Access Compliance Report Public Rights-of-Way (Curb Ramps)

Main Street: DODGE_AVE Cross Street: WHEMBLY_DR Location: NE

ADA ID: RPAT211018114644 Ramp Type: Type 3 - Combination 1 Initial Pass/Fail: Fail Overall Compliance: No Severity Score: 14

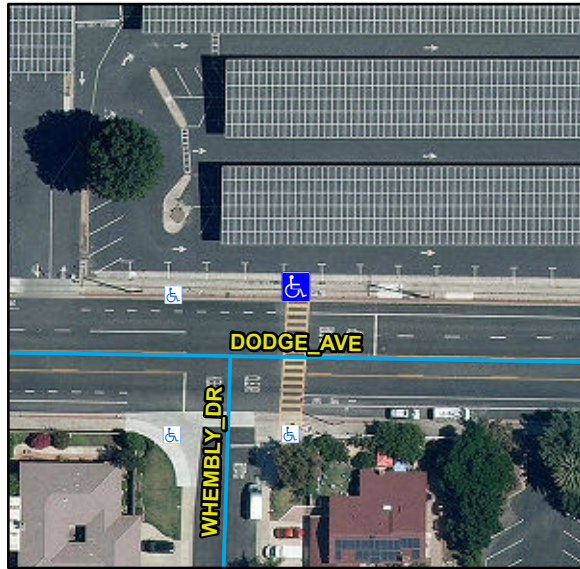
Compliance	Description	Data	Compliance	Description	Data
N/A	Ramp Length LT (in)	77	N/A	Ramp Length RT (in)	106
No	Ramp Width LT (in)	35	No	Ramp Width RT (in)	35
Yes	Ramp Run Slope LT (%)	4.8	Yes	Ramp Run Slope RT (%)	7
Yes	Ramp Cross Slope LT (%)	0.9	Yes	Ramp Cross Slope RT (%)	2
N/A	Ramp Length (in)	47	N/A	Flare Type LT	
Yes	Ramp Width (in)	49			N/A
Yes	Ramp Run Slope (%)	7.9	N/A	Flare Slope LT (%)	N/A
Yes	Ramp Cross Slope (%)	0.9	N/A	Flare Traversable LT	N/A
N/A	Landing Present	N/A	N/A	Flare Type RT	
N/A	Landing Length (in)	N/A			N/A
N/A	Landing Width (in)	N/A	N/A	Flare Slope RT (%)	N/A
N/A	Landing Run Slope (%)	N/A	N/A	Flare Traversable RT	N/A
N/A	Landing Cross Slope (%)	N/A	N/A	DWS Provided	N/A
N/A	Landing Movement Obstructed?	N/A	N/A	DWS Contrast	N/A
	Landing Movement Type	N/A	N/A	DWS Length (in)	N/A
N/A	Landing Shared	N/A	N/A	DWS Full Width	N/A
N/A	Clear Space	N/A		DWS Offset Type	N/A
N/A	Clear Space To Crosswalk (in)	N/A	N/A	DWS Offset Left (in)	N/A

N/A	DWS Offset Right (in)	N/A
Yes	Perp Joint Present	Yes			
	Parallel Ramp Side	N/A			
N/A	Marked Crosswalk 1	Yes	N/A	Marked Crosswalk 2	N/A
	Crossing 1 Direction	S		Crossing 2 Direction	N/A
	Marked Crosswalk 1 Width (in)	120		Marked Crosswalk 2 Width (in)	N/A
N/A	Ramp Inside Crosswalk 1	Yes	No	Ramp Inside Crosswalk 2	N/A
	Crossing 1 Slope (%)	5.5		Crossing 2 Slope (%)	N/A
	Crossing 1 Cross Slope (%)	1.2		Crossing 2 Cross Slope (%)	N/A
N/A	Gutter Ponding	N/A	N/A	Curb Slope	4.4
Yes	Gutter Lip Height (in)	0		Road Run Slope (%)	N/A
N/A	Gutter Run Slope (%)	N/A		Road Cross Slope (%)	N/A
N/A	Gutter Cross Slope (%)	N/A			
Yes	Overall Surface Condition: Acceptable				
	Cross Gutter Present?	No		Spandrel Present?	No
	Replace Cross Gutter?	N/A		Replace Spandrel?	N/A

Remove & Replace Entire Ramp. Remove & Replace Sidewalk.
